# **TBTT Information Field Type (TIFT) Clarification for P802.11REVmd**

**Date:** 2017-05-02

This contribution, intended for presentation to IEEE 802.11 TGM, identifies ambiguity in the TBTT Information Field Type (TIFT) subfield in the Reduced Neighbor Report. It proposes clarification, using the TIFT to specify additional properties of the reported neighbor.

Figure 9-582—TBTT Information Header subfield

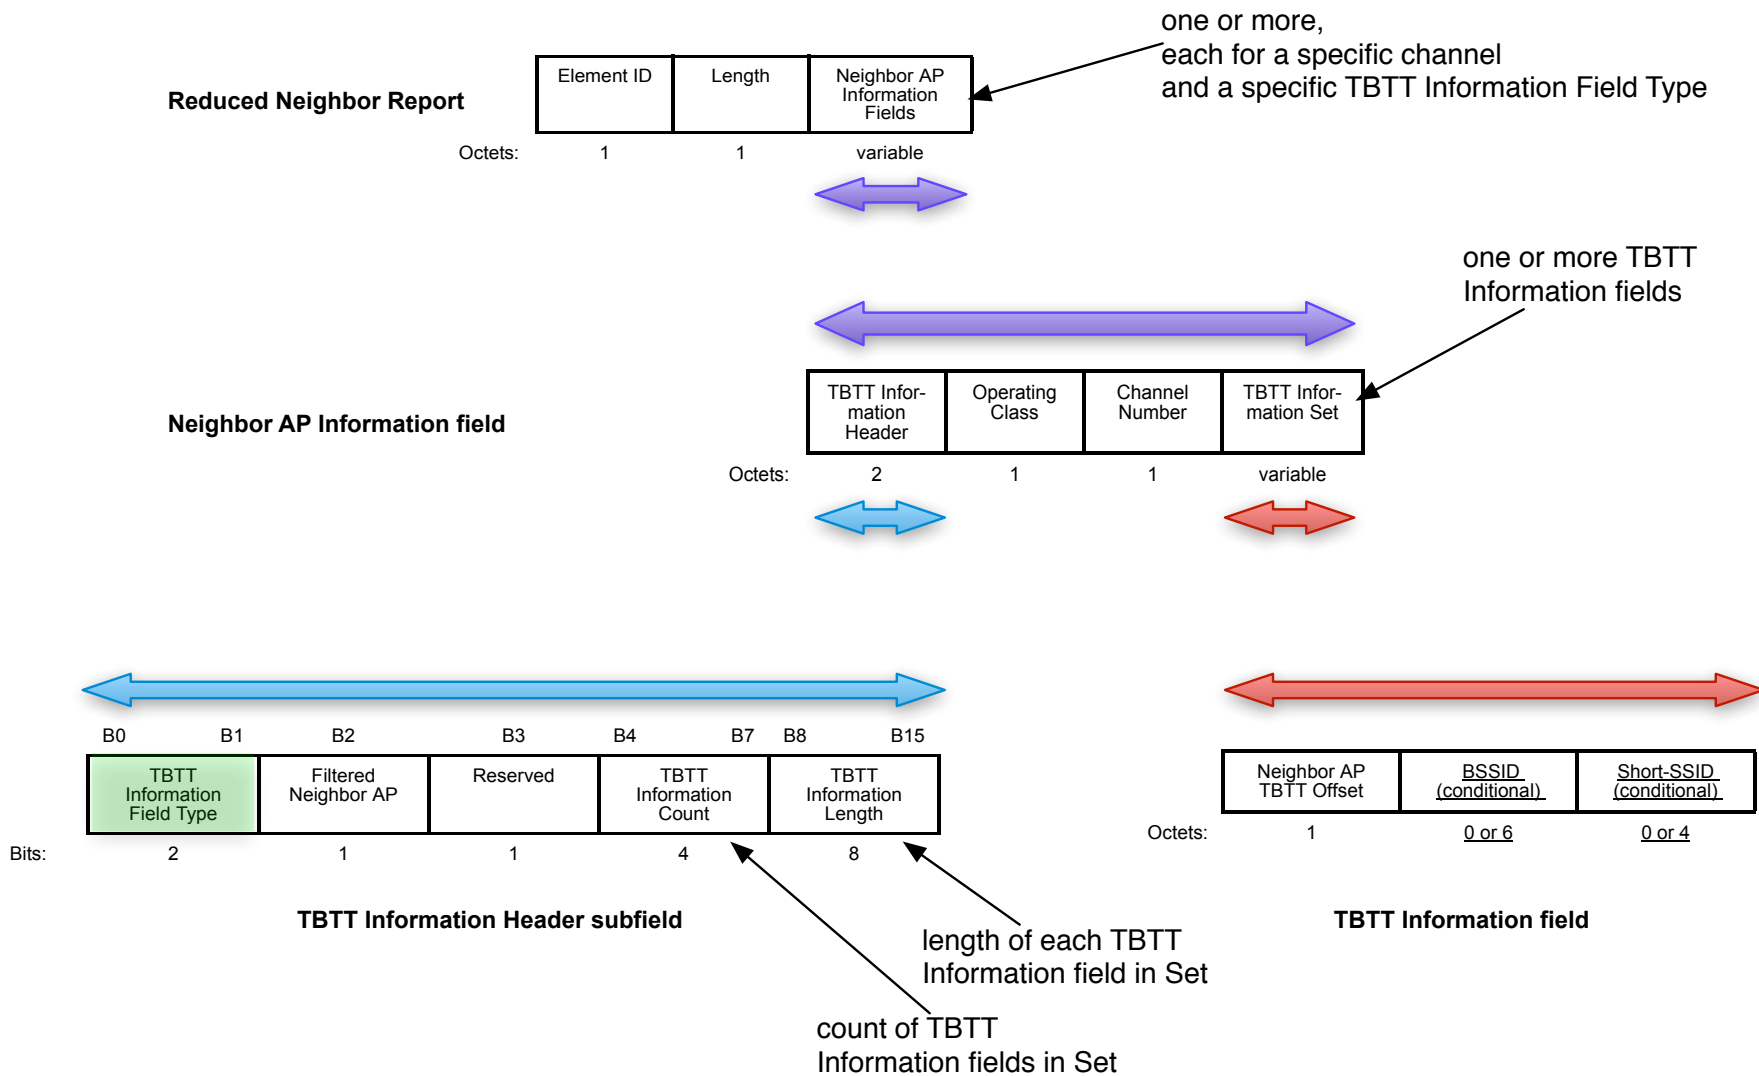
(1) The standard incorrectly states that the TBTT Information Field Type “defines the structure of the TBTT Information field”

- it does not, though it did in pre-standard drafts
- the name could therefore be improved, but that’s not proposed here

(2) How to resolve the ambiguity of the TBTT Information Field Type (TIFT)?

- What’s the purpose of adding a new value (1) of TIFT?
- How to specify the use of TIFT = 0 and 1?
- How to make use of TIFT 2 & 3?

**Table 9-258aa—TBTT Information Field Type**

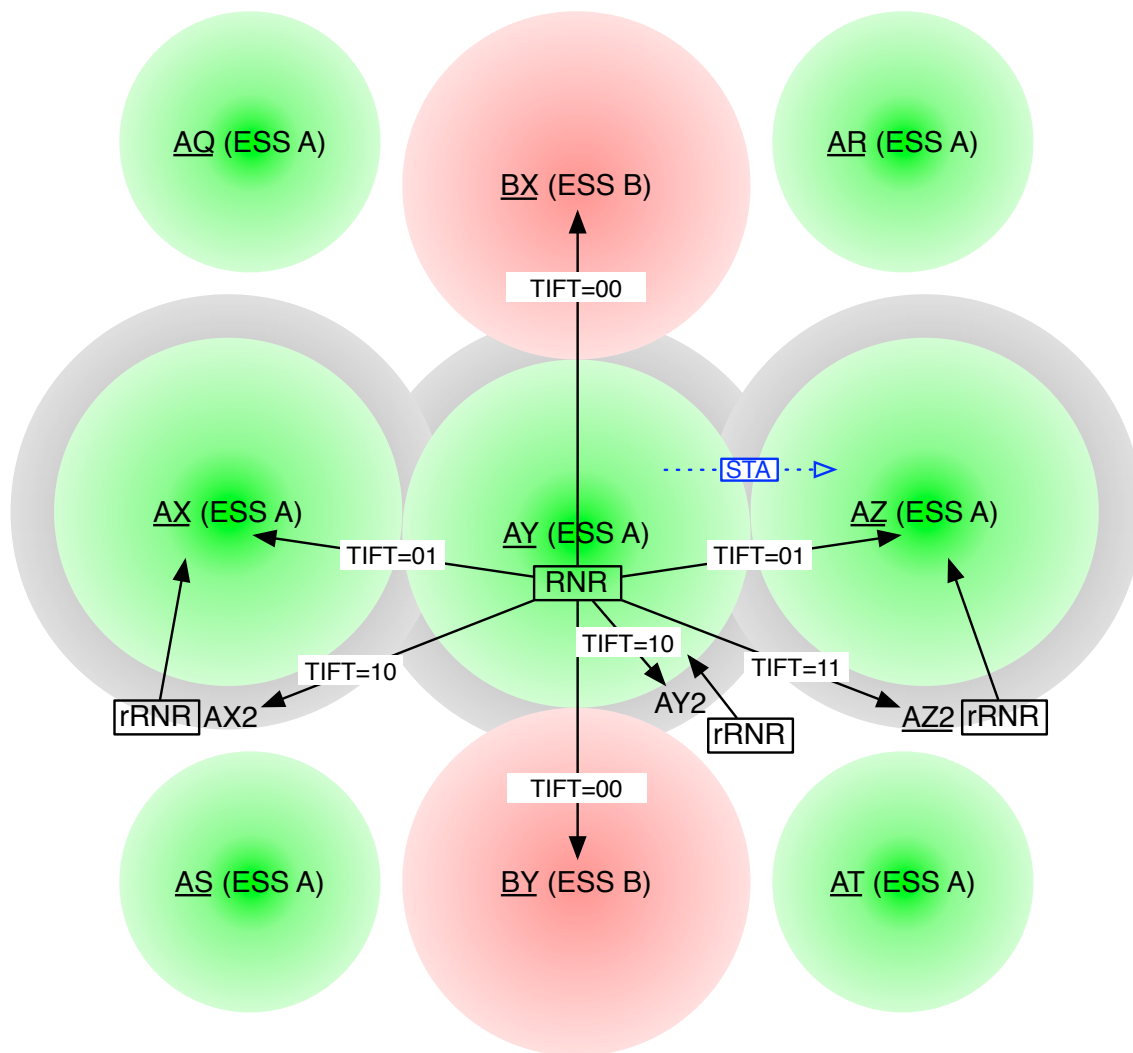
*The TBTT Information Field Type subfield is 2 bits in length ~~and defines the structure of the TBTT Information field. Values 2 and 3 are reserved~~ and set in accordance with Table 9-258aa.*

TBTT Information Field Type bit	Meaning
Bit 0	Each neighbor designated in the Neighbor AP Information field is an AP that belongs to the same ESS as that of the AP sending this Reduced Neighbor Report and is suitable for BSS transition and reassociation.
Bit 1	Each neighbor designated in the Neighbor AP Information field is a rendezvous neighbor, which identifies, in its own rendezvous Reduced Neighbor Report, only APs that belong to the same ESS as that of the AP sending this Reduced Neighbor Report and are suitable for BSS transition and reassociation.
